Date: May 03, 2007

To: T10 Committee (SCSI)

From: George Penokie (IBM)

Subject: SAM-4: Changes requested from 03/2007 editing session

Figure 1 — SCSI initiator device class diagram

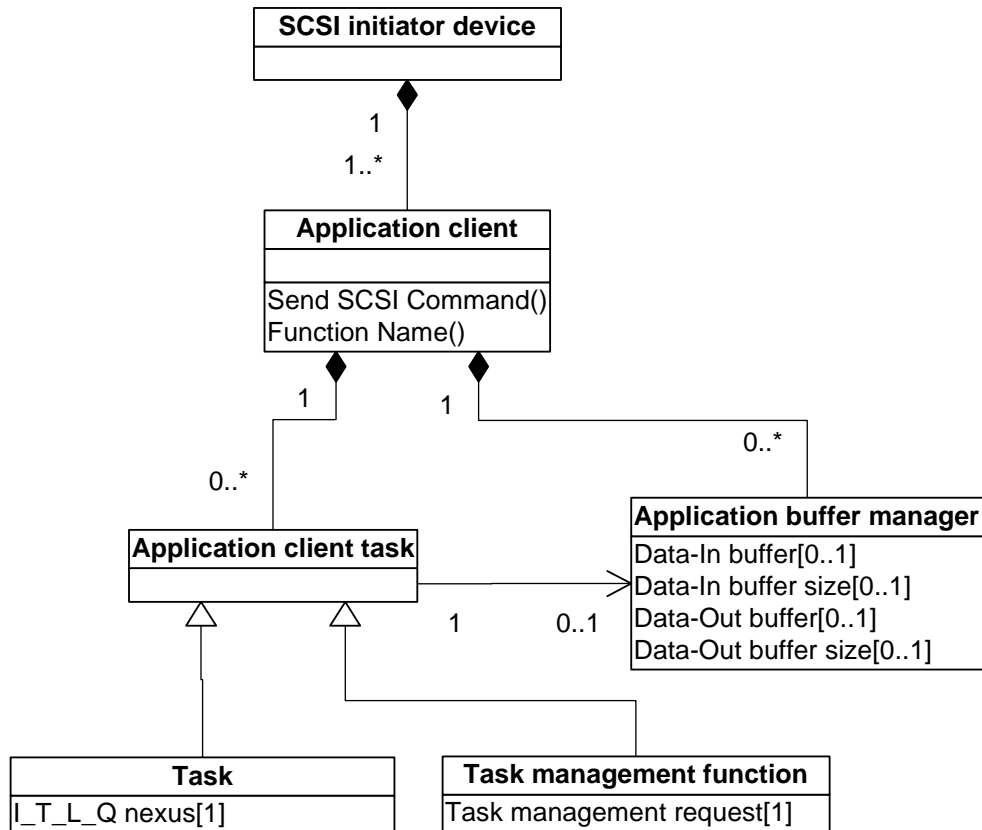
During the SAM-4 editing session in March it was requested that the UML diagrams be enhanced to include all the parameters that are listed in the Execute Command procedure call and to add in associations between some of the classes in the SCSI initiator device and the logical unit class diagrams. This proposal makes those changes.

- a) ~~A SCSI initiator device application client~~ class (see figure 19)(see 4.5.10) is a SCSI device class that contains the:
  - A) application client ~~task~~ class (see 4.5.10) that contains the:(see 4.5.12); and
  - B) application ~~client task~~ ~~buffer manager~~ class (see 4.5.11)(see 4.5.11).

- a) one or more application clients that contain:
  - A) ~~one-zero~~ or more application ~~clients that contain:~~ client tasks: and

B) zero or more application client ~~tasks~~buffer managers.

**Figure 2 — Task class diagram**

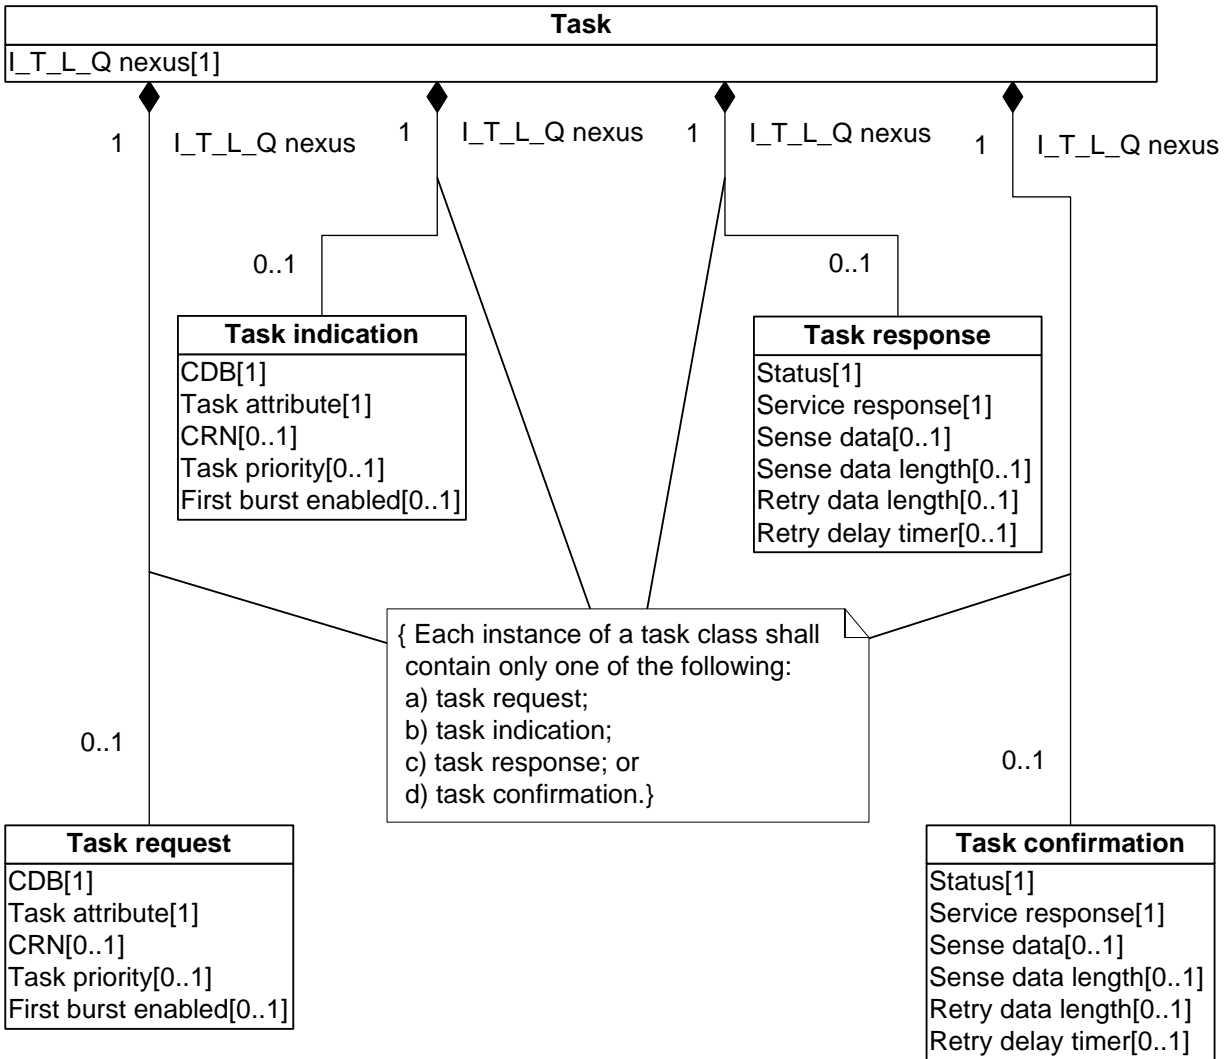
- a) [task request class](#) (see 4.5.15);
- b) [task indication class](#) (see 4.5.16);
- c) [task response class](#) (see 4.5.17); and
- d) [task confirmation class](#) (see 4.5.18).

~~Each instance of a task class represents the work associated with a command.~~ A new command causes the creation of a ~~task~~ task class. The task class persists until a ~~task command~~ complete response confirmation is ~~sent received~~ or until the task is ended by a task management function or exception condition. For an example of the processing for a command see 5-75.7.

Figure 3 — Logical unit class diagram

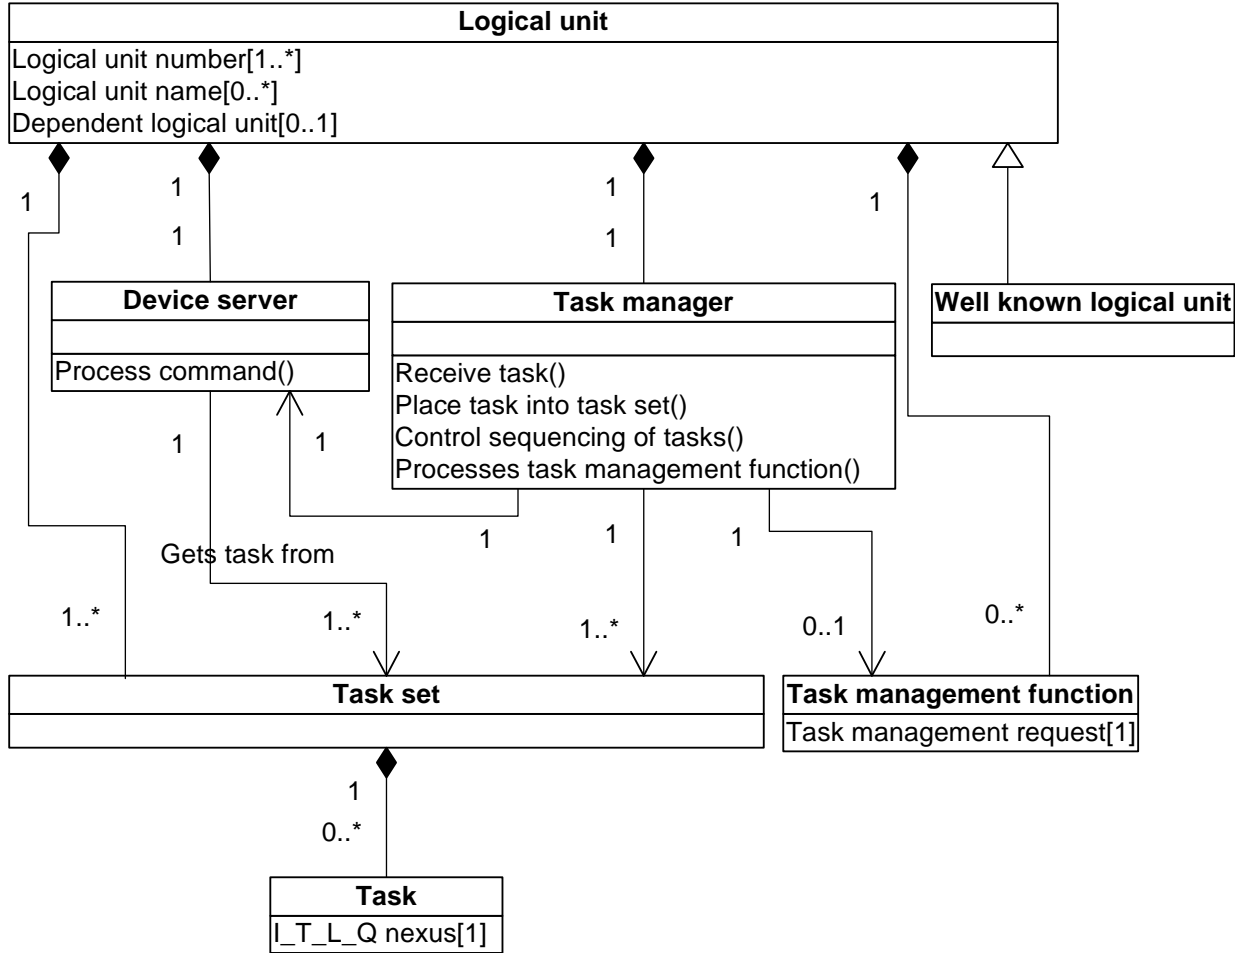
A logical unit class (see figure 13) contains the:

- a) device server class (see 4.5.25);
- b) task manager class (see 4.5.26); and
- c) task set class (see 4.5.27).
